# UNITED STATES PATENT AND TRADEMARK OFFICE

APPLICATION NO.	FILING DATE	FIRST NAMED INVENTOR	ATTORNEY DOCKET NO.	CONFIRMATION NO.
10/083,093	02/26/2002	Jeffrey J. Shea	10557/266546	5422

# Office Action Summary

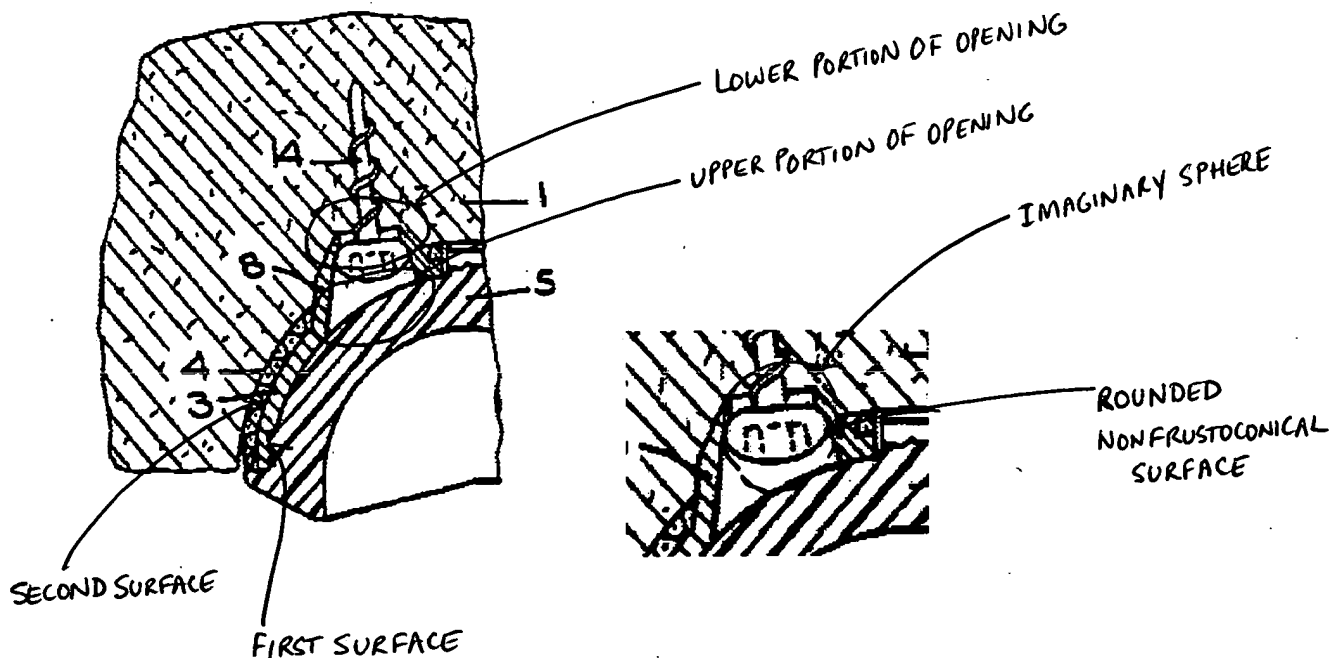
Marchetti et al. disclose an implantable prosthesis including: a metal shell or "prosthetic component" 3; at least one opening extending from a first surface to the second surface of component 3, the opening having a nonthreaded frustoconical upper portion and a lower portion; a screw or "insertion member" 14 with a rounded non-frustoconical contact surface that contacts the frustoconical taper section of the opening

and does not contact the lower portion of the opening (Fig. 4, col. 2, lines 39-68 and col. 3, lines 1-44). See marked up Fig. 4 from Marchetti et al. below.

Regarding claims 6, 35 and 42, the rounded surface of the head of insertion member 14 is part of a sphere or "imaginary sphere" as shown in marked up Fig. 4 below.

**Fig. 7**

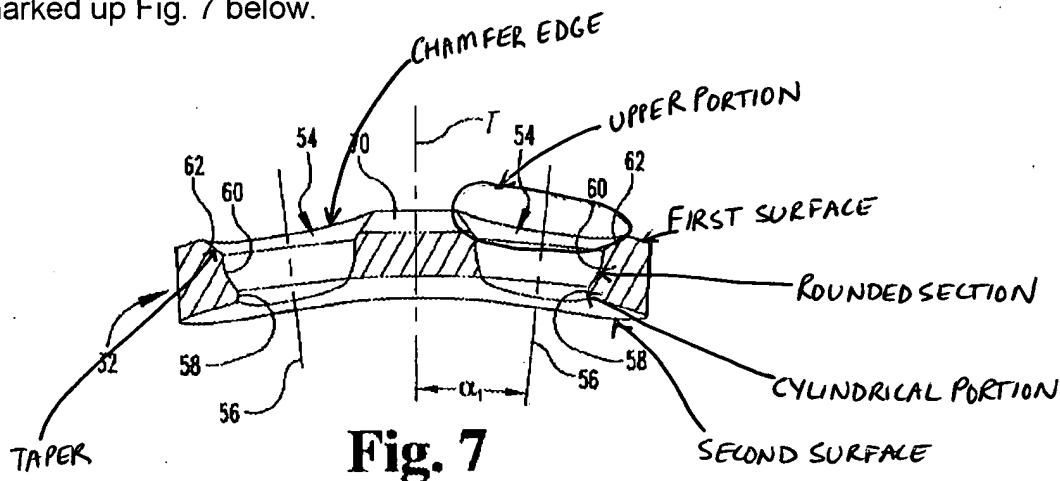
Justis et al. disclose a device or "implantable prosthesis" 20 including: a prosthetic component 22 having first and second surfaces; at least one opening 54 extending from the first surface to the second surface; each opening 54 further including a chamfer edge, an upper portion with a taper, a rounded section and a cylindrical portion; and wherein the rounded section has a smaller diameter than the conical taper

(Figs. 1, 7 and 8, col. 4, lines 31-45, col. 5, lines 26-49 and col. 8, lines 33-58). See marked up Fig. 7 below.

It is noted that the upper portion extends through a large part of the thickness of the plate and thus meets the limitation, "substantial portion" of the opening.

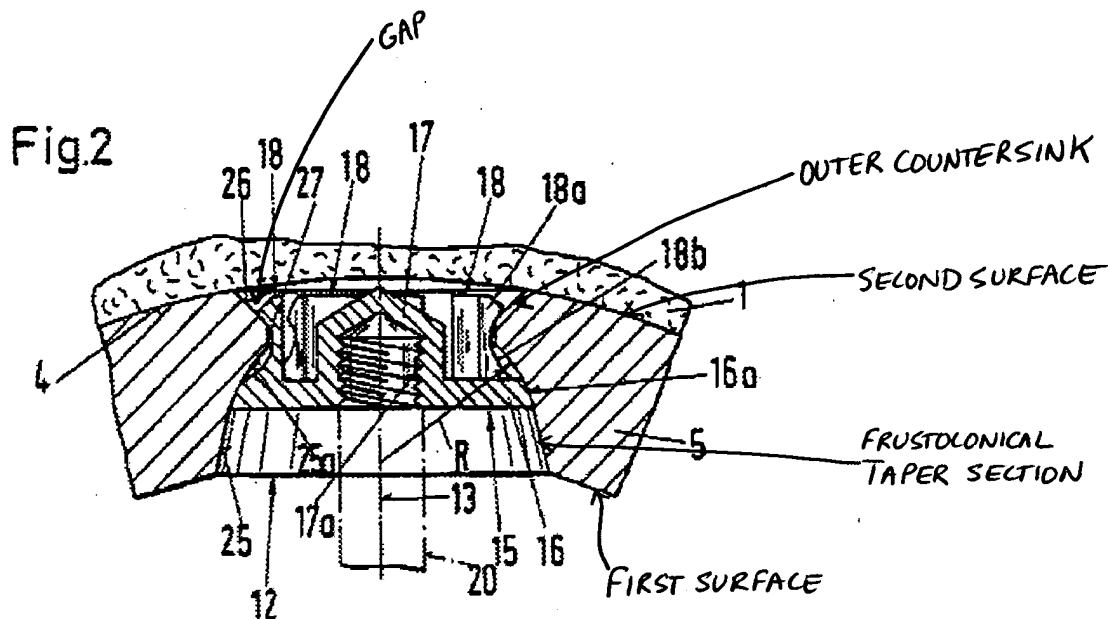
The Examiner notes that Oehy et al. clearly disclose that opening 12 receives a screw 14 and permits angular positioning of screw 14 in opening 12 (Fig. 2, col. 2, lines 54-65 and col. 3, lines 10-18). It is the Examiner's position that depending on the angular position of screw 14 in opening 12, the spherical surface 14a of the screw head would contact and be locked relative to frustoconical surface 25 in a manner similar to

Applicants' invention (Fig. 5). Further, head 14a does not contact the lower portion, namely, outer countersink 26. See marked up Fig. 2 from Oehy et al. below.

On page 20, Applicants' argue that Oehy et al. does not disclose "a gap between the second surface of the prosthetic component and a bottom of the insertion member head." It is the Examiner's position that there is a gap due to the outer counter-sink 26.
